NATIONAL FIRE PROTECTION ASSOCIATION

TO: Technical Committee on Sprinkler System Discharge Criteria

DATE: January 6, 2023

SUBJECT: NFPA 13 First Draft TC FINAL Ballot Results (A2024)

Figure A.28.2.4.2.5 Point of Connection for Additional Flow.

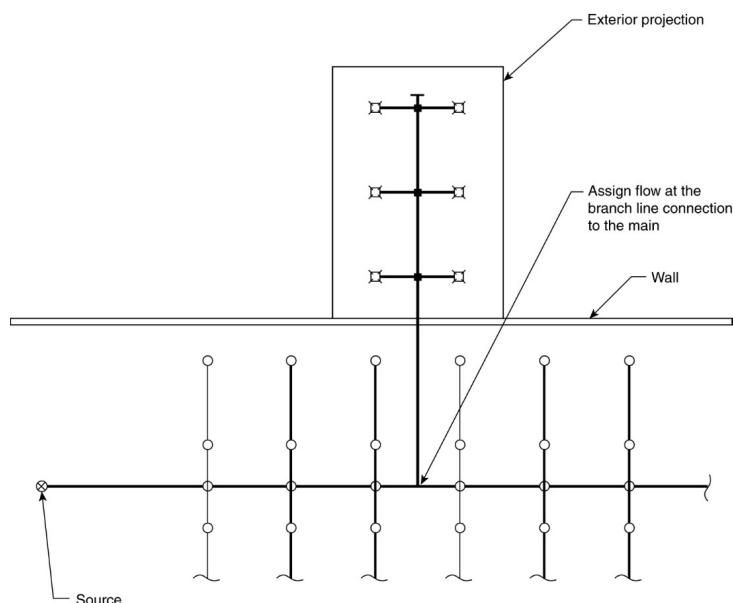
Committee Statement: In the 2022 edition, A.28.2.4.2.4 text is inaccurately referenced to 28.2.4.2.4 and should be associated with 28.2.4.2.5. Added text to refer the user to Figure A.28.2.4.2.5 for an example of where to add the additional flow.

See Figure A.28.2.4.2.5 for an example of the point of connection for additional flow.

Figure 25.7.2.3.1(a) In-Rack Sprinkler Arrangements for Class I through Class IV and Group A Plastic Commodities.

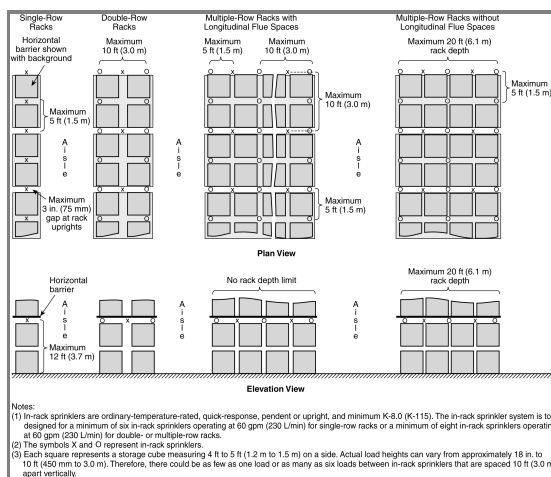
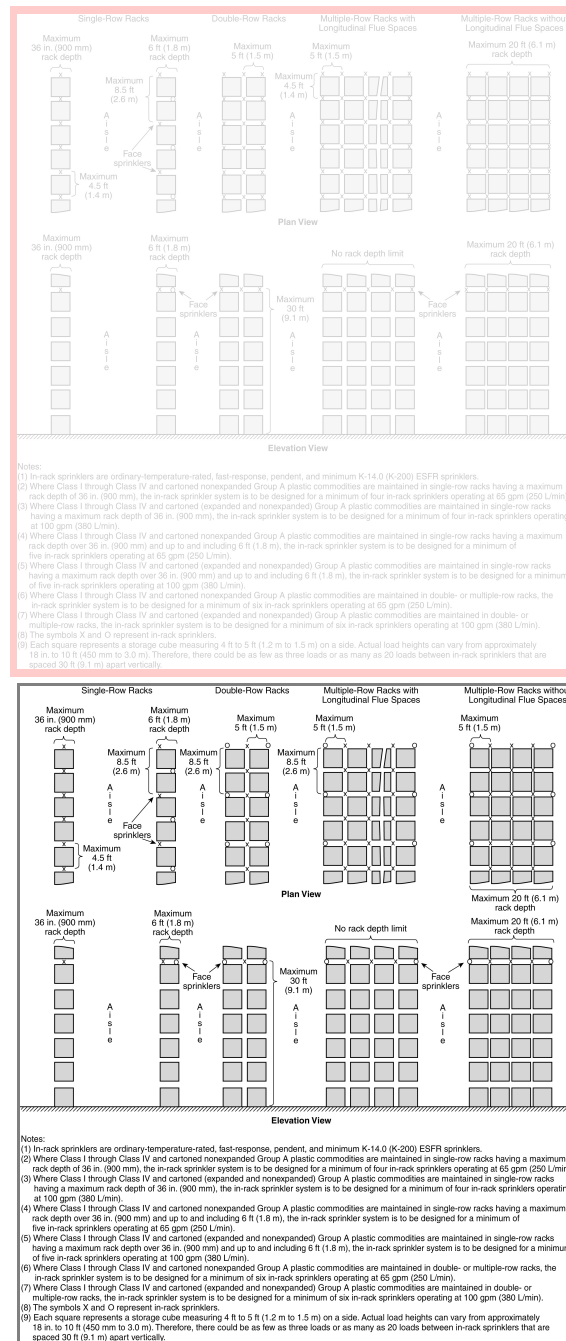
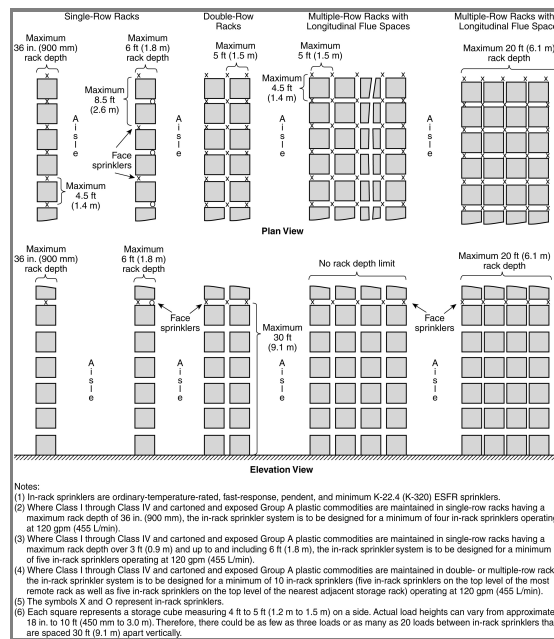
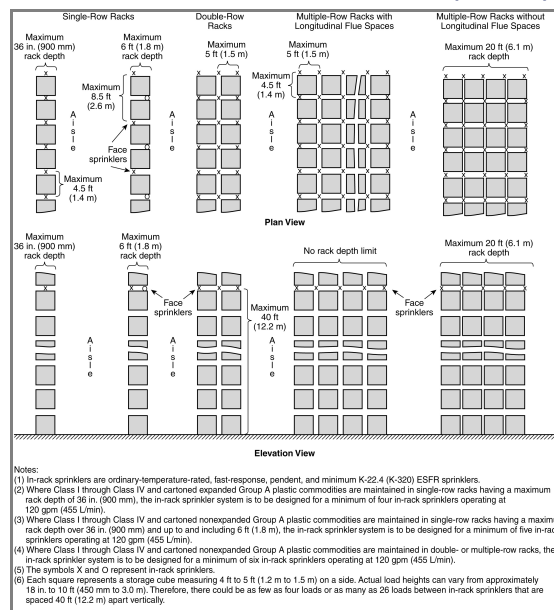
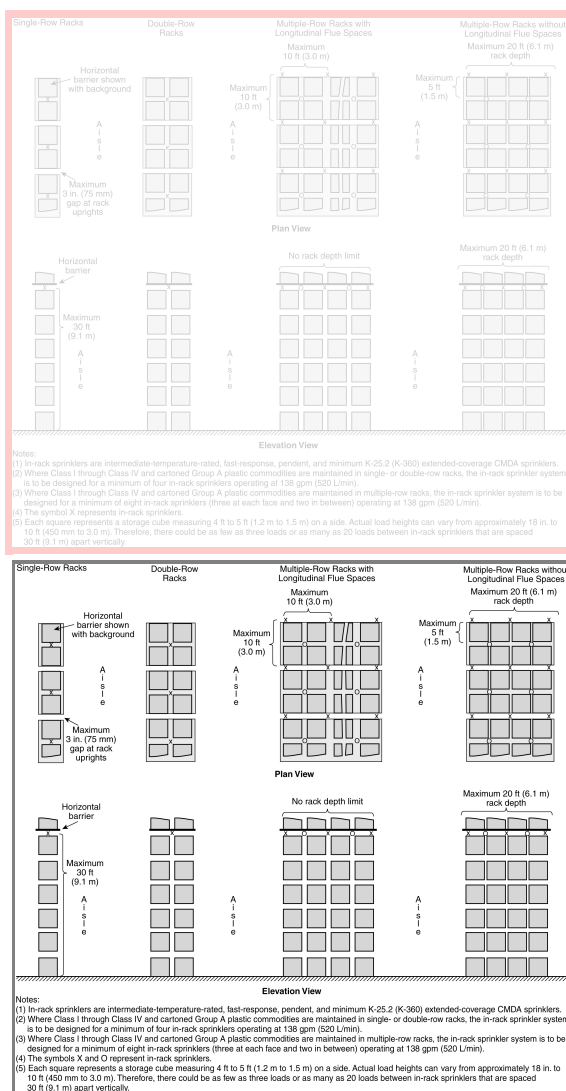
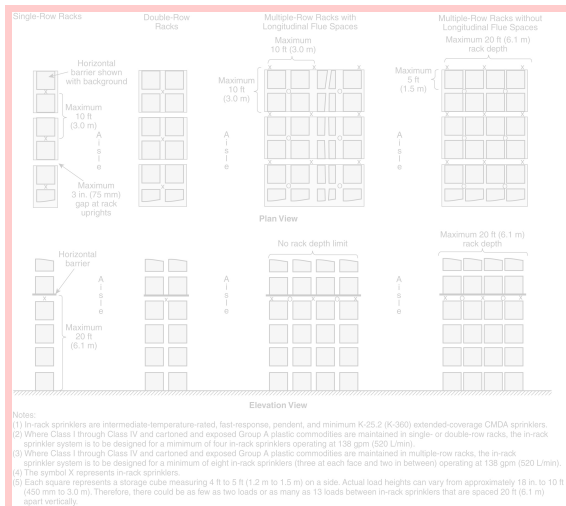
Committee Statement: The in-rack sprinklers are indicated with both X and O and the note to the figure should indicate that. Figure 25.6.2.3.1(b) was revised to align with the 2016 edition figure.

Figure 26.6.6.4 Sprinkler Location and Spacing in Transverse Flues.

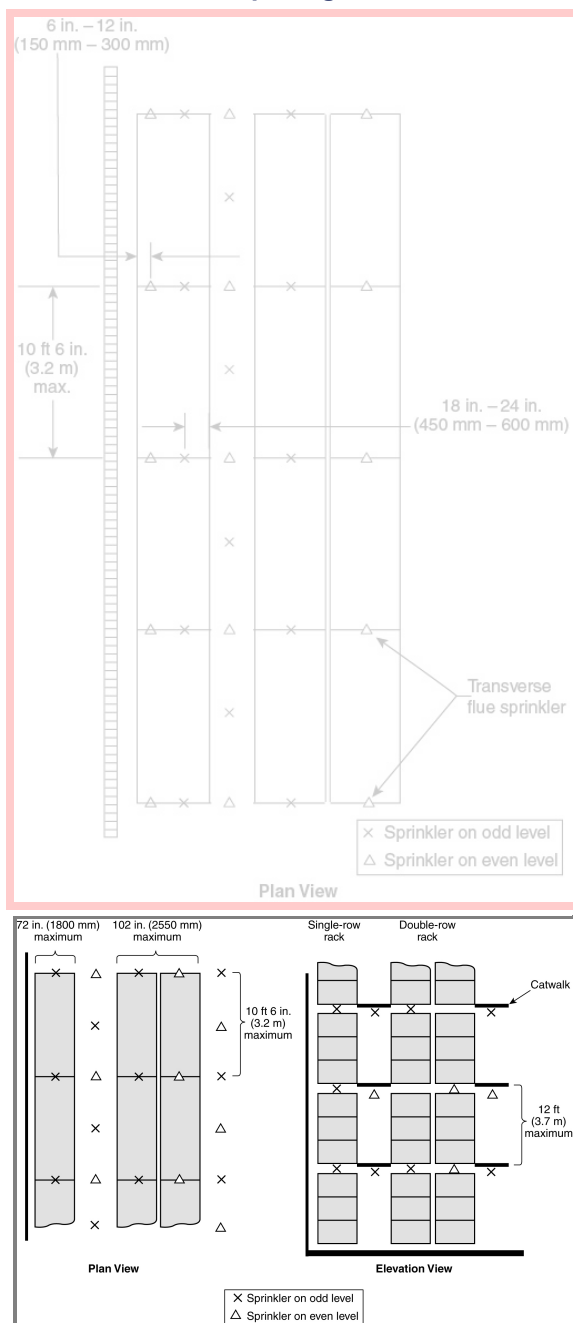
Committee Statement: The in-rack sprinklers in the single row racks should all be within the 18" to 24" location to the face of the rack on each level. Also see change to Figure 26.6.6.4.
Response Message: FR-1239-NFPA 13-2022
